# PREVOST

## WARRANTY BULLETIN

### WB23-22A

DATE :	October 2023	SECTION :	18 BODY
EXPIRATION:	October 2025		
SUBJECT :	<b>PARCEL RACK DOOR HANDLE REPLACEMENT (WITHOUT LOCK)</b>

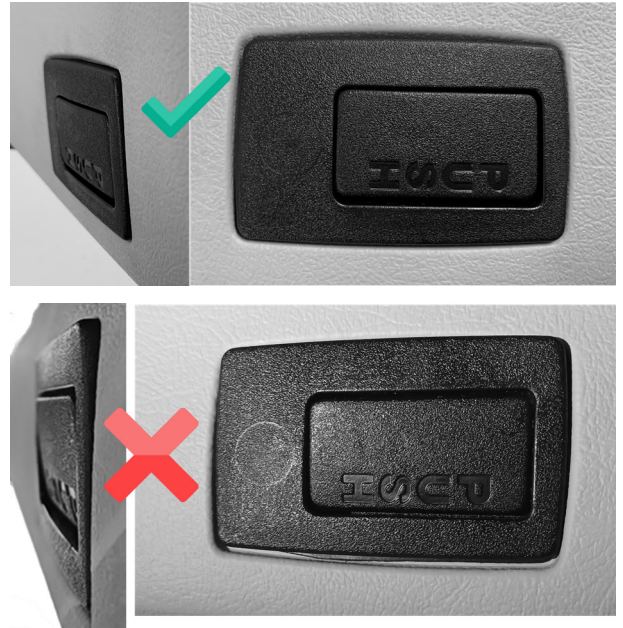
On the vehicles affected by this bulletin replace parcel rack door handle without lock and catch by new improved model 810013 and 313667.

3. Install the handle 810013 use the bracket and screws (2x) include with the handle.

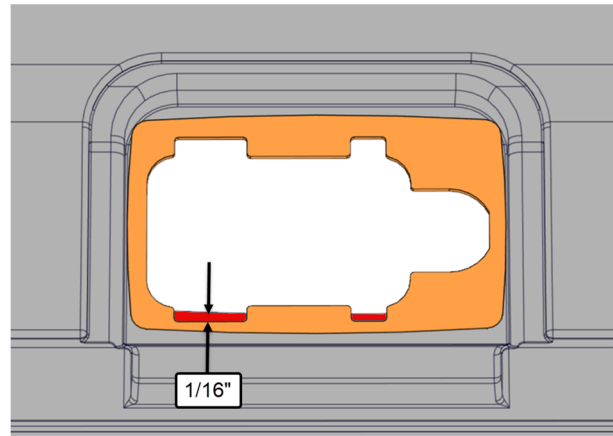
4. How to verify if the door handle is in the correct position. See pictures.
5. If you are not able to correctly install the door handle, go to the next step.

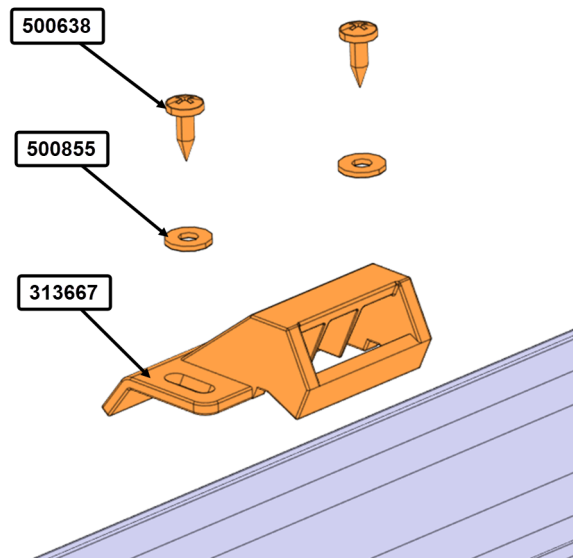
Revision: A

Add adjustment for door handle hole.

6. Modify the door handle hole.
7. Use the gasket of the door handle as template to mark the location of the two notches to grind.
8. Grind two notches on the door panel.
